From: [REDACTED]
To: [MD Marine Renewables](#)
Subject: MD-00011742 & MD00011743 Spiorad na Mara Limited - Spiorad na Mara Offshore Wind Farm - Isle of Lewis
Date: 04 May 2026 23:28:36
Attachments: [Objection spiorad na Mara App ref 00011742 and 00011743.pdf](#)

FORMAL OBJECTION TO THE SPIORAD NA MARA OFFSHORE WIND FARM

To: Marine Directorate Licensing Operations Team Re: Section 36 Consent Application — Spiorad na Mara Offshore Wind Farm Application references: 00011742 & 00011743

Plate 3-1 Looking south at the remains of Teampull Eoin (SM3926)

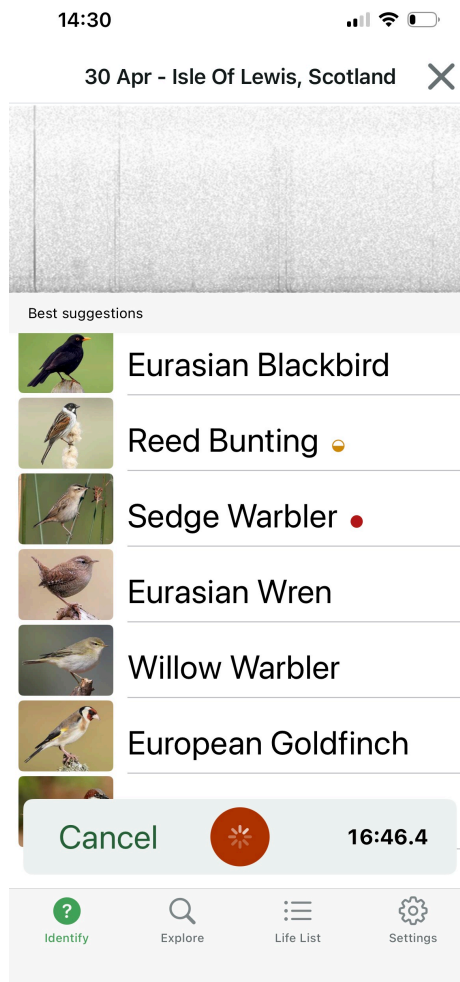
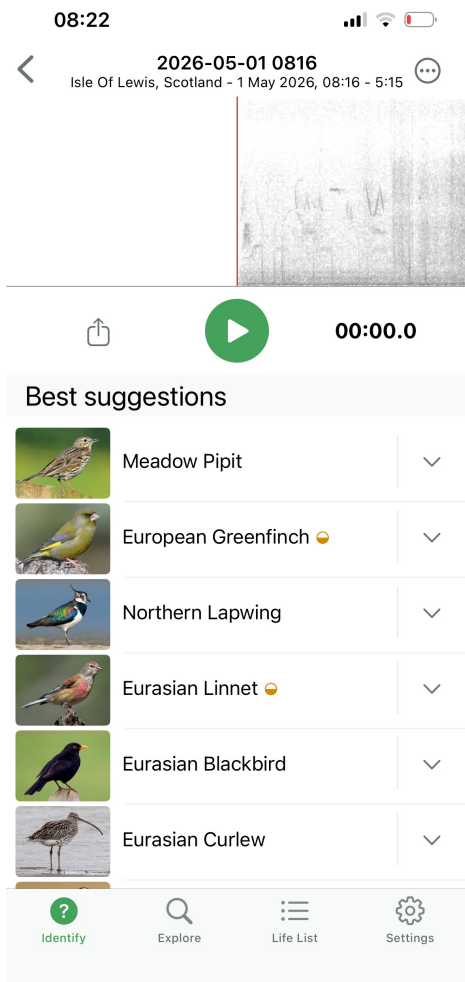
I have taken photographs of Teampall Eoin at Port Mòr in Bragar (attached) that show the chapel, the cemetery, and the wider seascape in which they sit. The applicant's own photomontage for this site was taken looking away from the sea. I have also taken photographs of the Arnol Blackhouses that show the extent to which the sea is integral to the appreciation of those buildings and their landscape. The relationship between the

Teampall Eoin and Cladh Bragar (Bragar Cemetery) are visible in the bright green square to the right of the image below, showing the context of the monument and cemetery within the wider landscape and seascape facing west.

Within the cemetery with Teampall Eoin to the right.

Arnol Blackhouses on both sides of the road with a wide aspect of the Atlantic horizon.

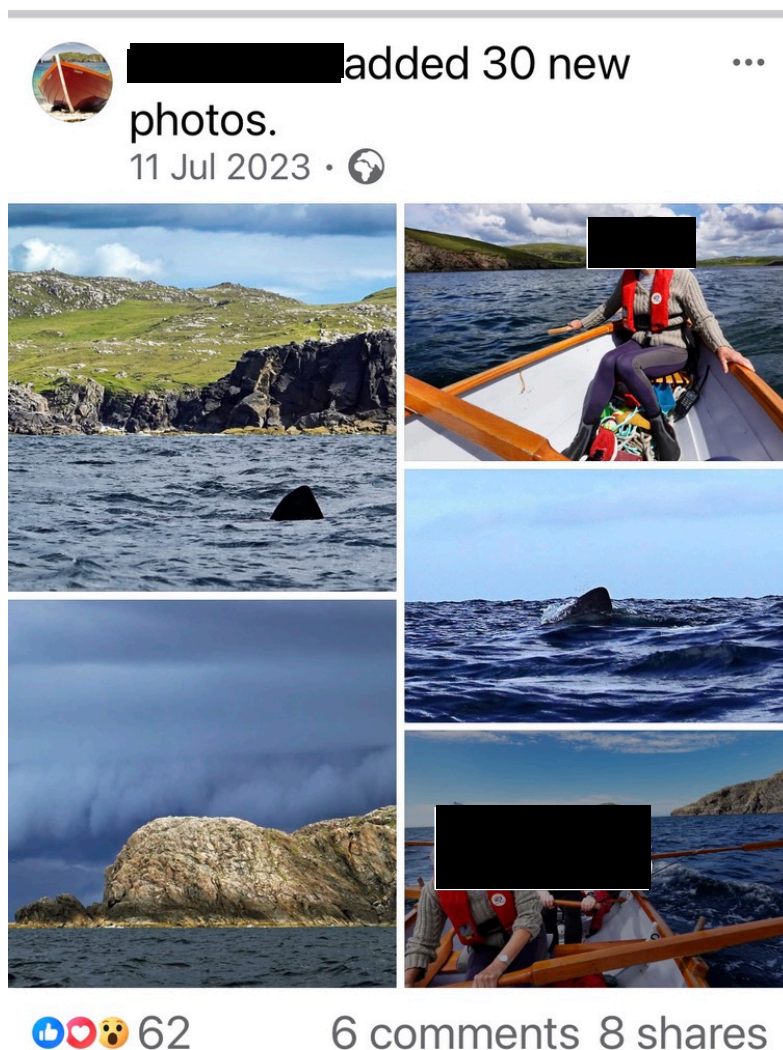
blackhouses and the western horizon is central to its cultural significance. The applicant's assessment does not engage with this relationship.
